MEMORANDUM

From: Stephen Chiles, Chiles Ltd
To: Pam Butler, KiwiRail
Date: 12 February 2021
Subject: KiwiRail Regional Freight Hub -
Response to requests for information relating to noise and vibration

Palmerston North City Council has requested further information relating to KiwiRail's Notice of Requirement for the proposed Regional Freight Hub (PNCC letter dated 14 December 2020). Items 7 to 31 of the request for information relate to noise and vibration. Responses to those items are provided in this memo. For each item the request is written in italics followed by the response. Several responses refer to a set of 17 figures that are attached to this memo.

Project: Central North Island Freight Hub
 Client: KiwiRail
 Title: Figure 1
 Proposed Noise Management Boundary

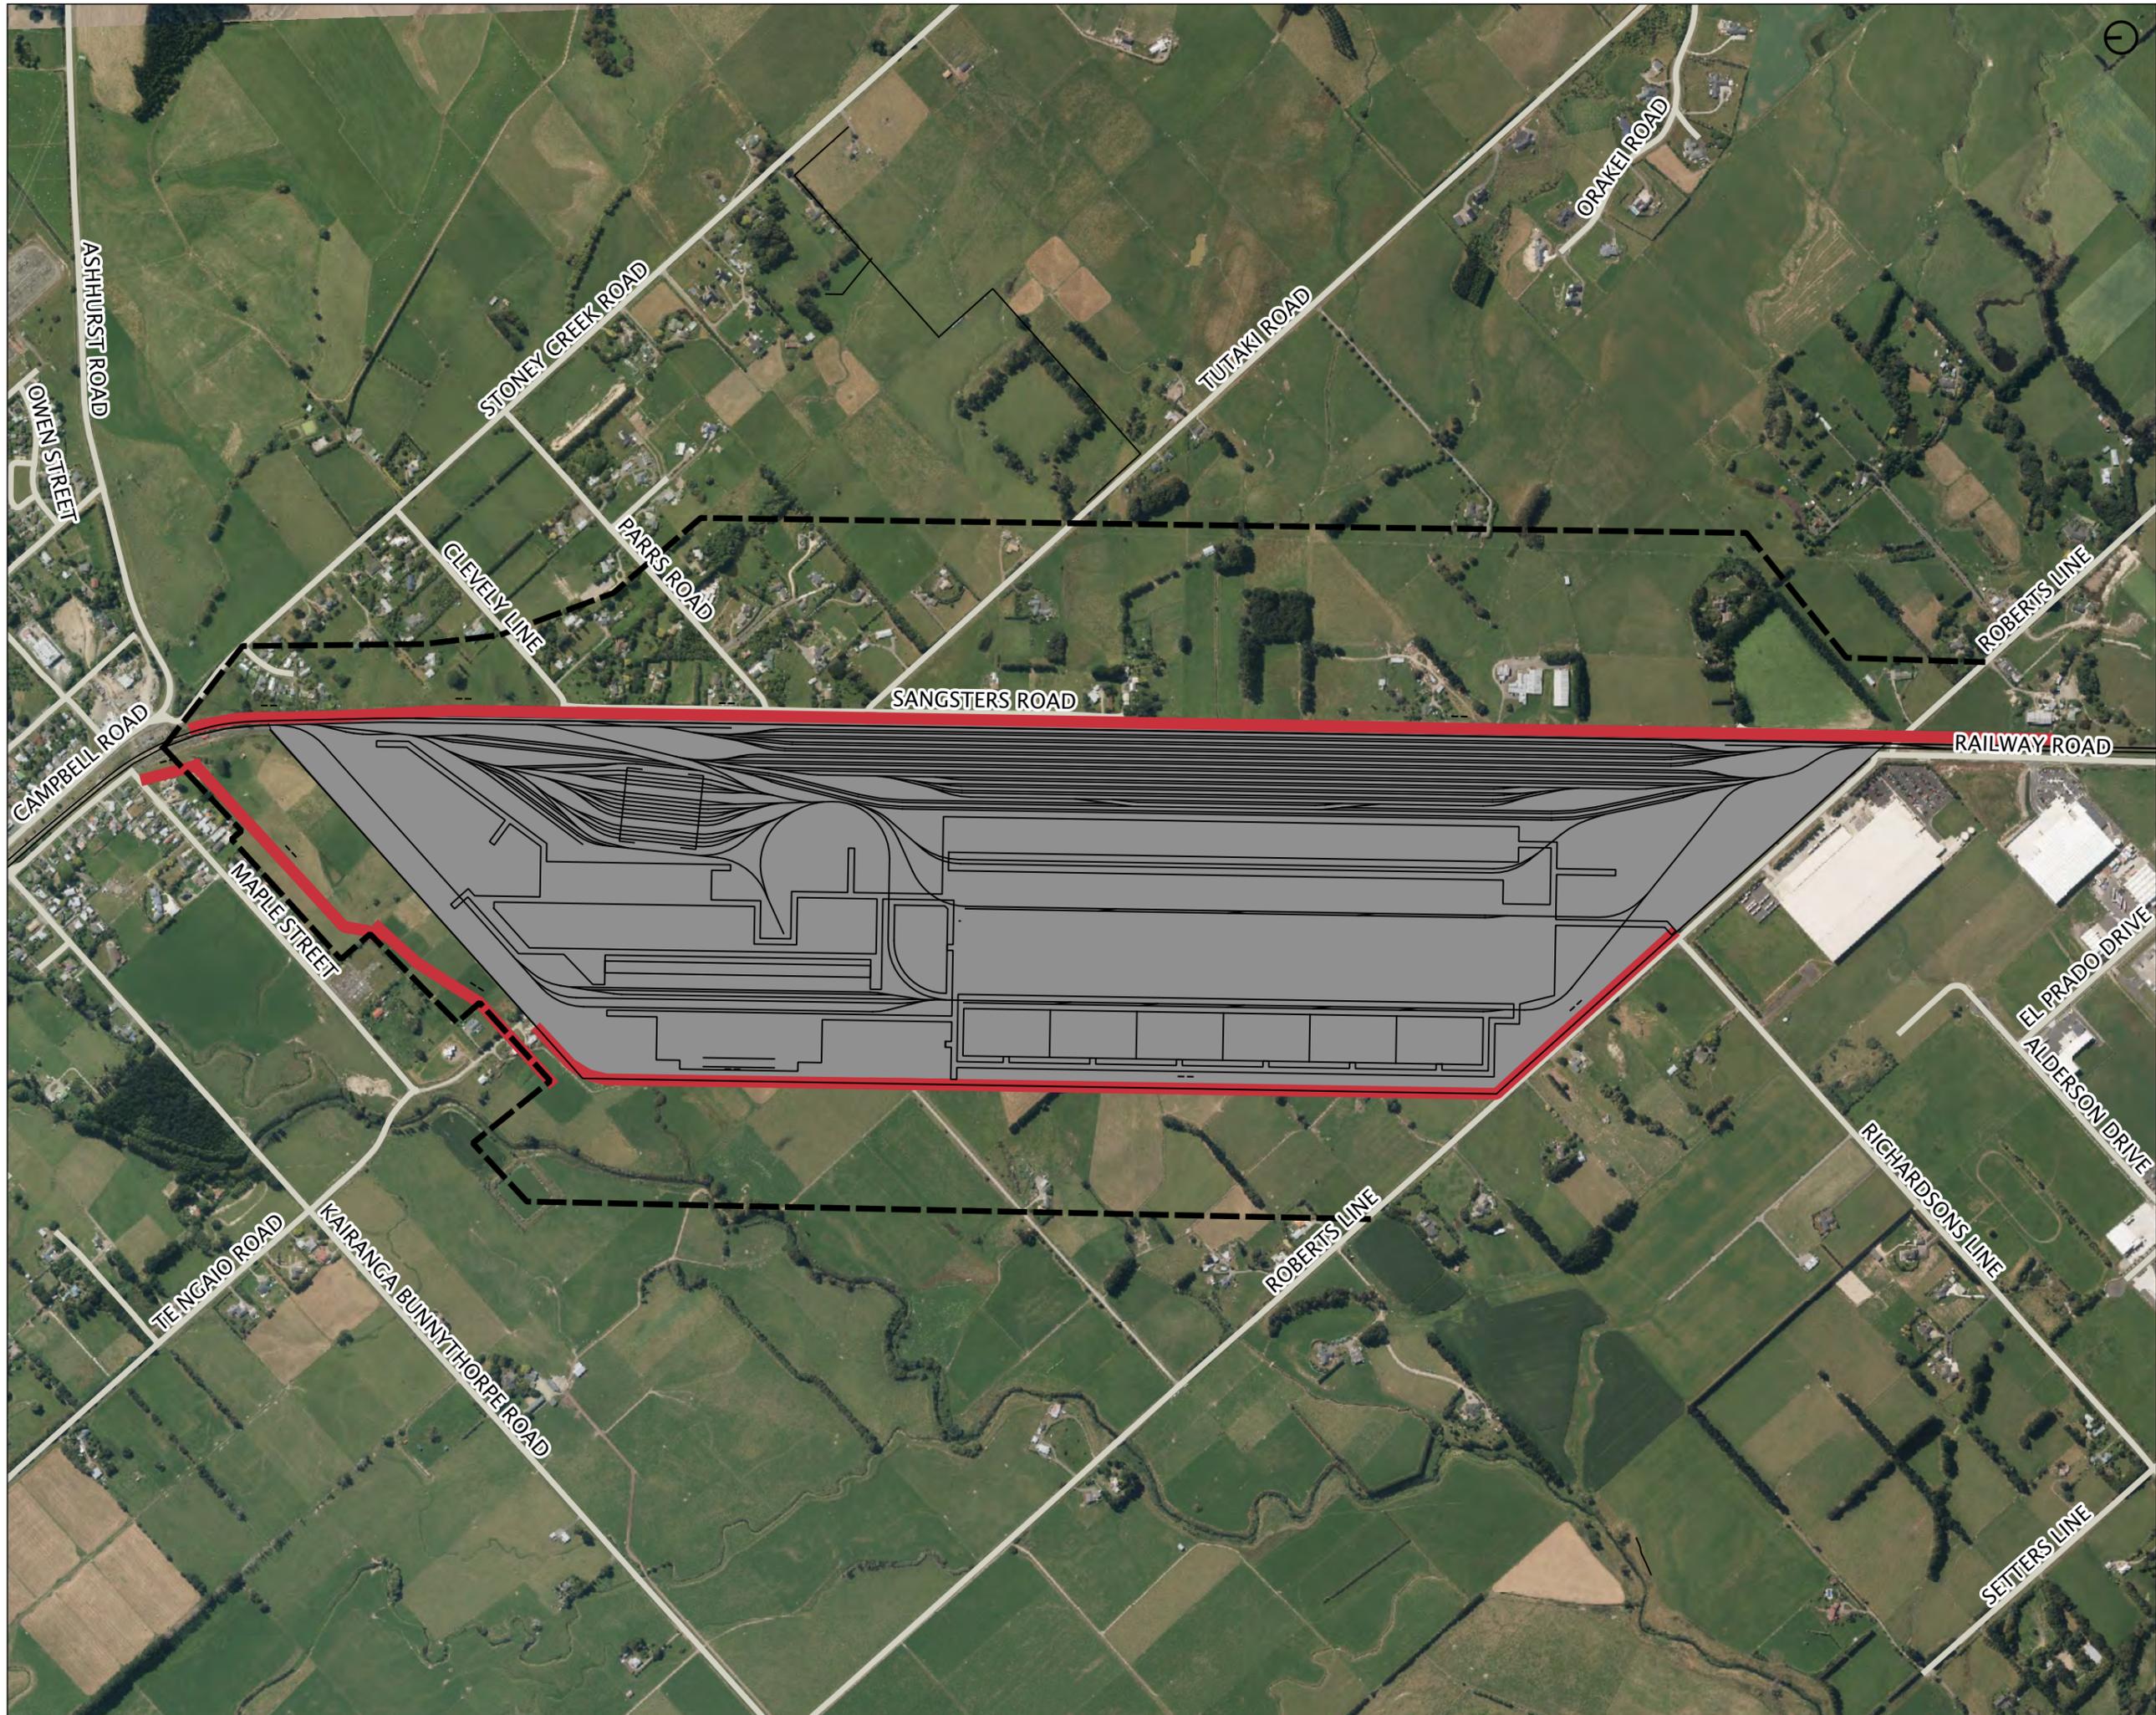
Please provide predictions of noise management boundaries for the Regional Freight Hub.

In response to the request for information, a potential 'noise management boundary' line has been produced and is attached as Figure 1. This line is based on an operational (on-site) noise level of 55 dB $L_{Aeq(1h)}$. This noise level has been selected for the management boundary as it is the most stringent daytime criterion proposed in Technical Report D (Table 5, page 18). Use of this particular noise level also results in a pragmatic location for the management boundary in that it should be close enough to the site to measure sound levels from site activity without too much contamination from other sound sources. At the same time the management boundary is far enough from the site to be representative of noise exposure of potentially affected houses.

The proposed boundary has been drawn with the following assumptions:

- The data has been taken from the modelling presented in Figure 12 of Technical Report D. The noise level relates to a height 1.5 metres above the ground. This modelling excludes all activity on the NIMT and the new perimeter road.
- The noise contour has been smoothed to reduce effects of modelling artefacts. It can be seen that the noise contours in Figure 12 of Technical Report D 'wobble' in and out along each side of the

site. These wiggles have been smoothed to result in a management boundary made up of straighter lines.

- A 2 dB tolerance has been added to provide some allowance for uncertainty. This is required both due to the limitation of information available prior to detailed design and due to the modelling accuracy. A 2 dB tolerance has been chosen to provide a pragmatic boundary. The use of a 2 dB tolerance is consistent with normal professional practice as applied for other environmental noise sources.
- The management boundary is a minimum distance of 100m from the site boundary, at the ends of the east site boundary.
- The management boundary has been extended to the property boundaries at the north.
- The North East Industrial Zone has been excluded as it should not contain noise sensitive activities, where the criteria proposed in Technical Report D (Table 5) apply.

Project: Central North Island Freight Hub
 Client: KiwiRail
 Title: Figure 2

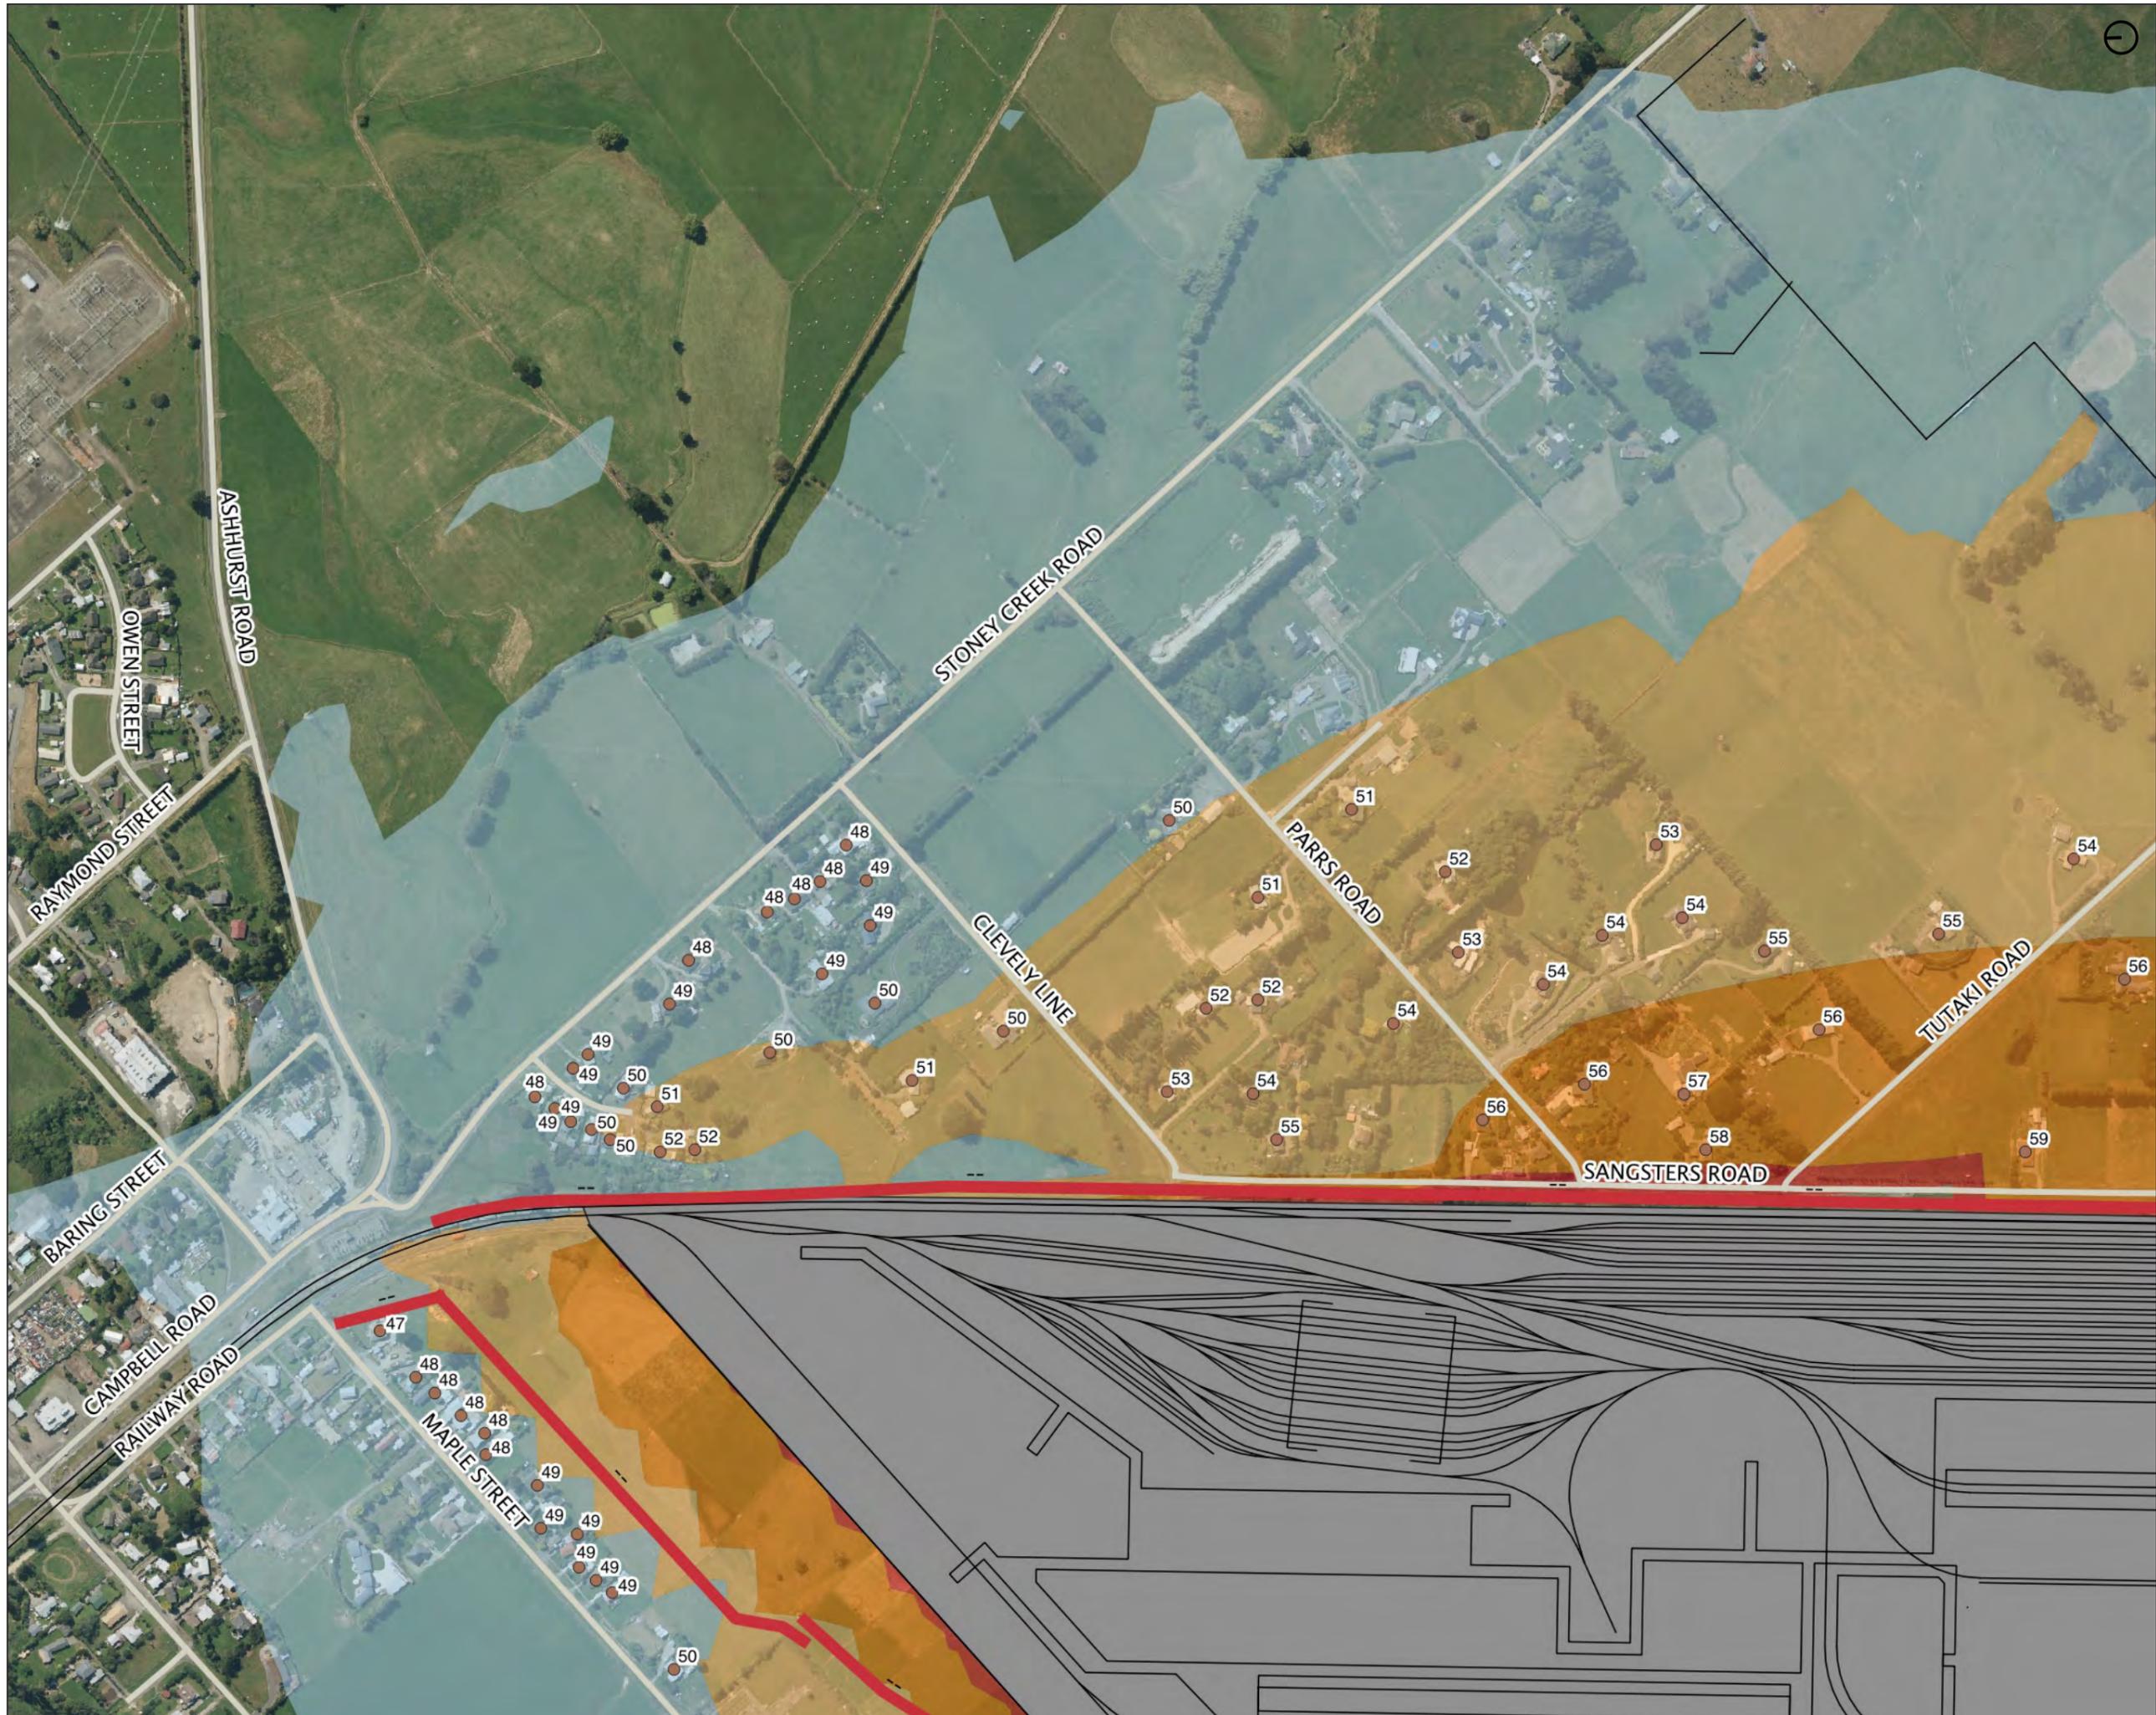
With respect to 8 & 9 above please provide daytime noise management boundaries predicted at 5 dB increments between 70 dB LAeq (1hr) and 50 dB LAeq (1hr).

Please provide the predicted noise levels for individual dwellings or representative groups of dwellings with the predicted levels for the various scenarios (i.e. for the different screen heights). Sites on which dwellings can be constructed as a permitted activity and commercial buildings also need to be identified.

The spatial distribution of other indicative LAeq(1h) noise contours is shown in Technical Report D Figure 12 (page 38). To aid reading of this figure the data has been reproduced at a larger scale and is attached as Figures 2 to 7. The range of noise contours shown is from 65 dB to 45 dB. Beyond this range contours are either within the site or extend over too great a distance for meaningful predictions.

To aid reading of Technical Report D Figure 12 (page 38) the data for the scenario with noise barriers has been reproduced at a larger scale in the attached Figures 2 to 7. The indicative sound level has been annotated on each building that has been assumed to be a house. At this stage houses near the site have been identified from inspection of aerial photographs.
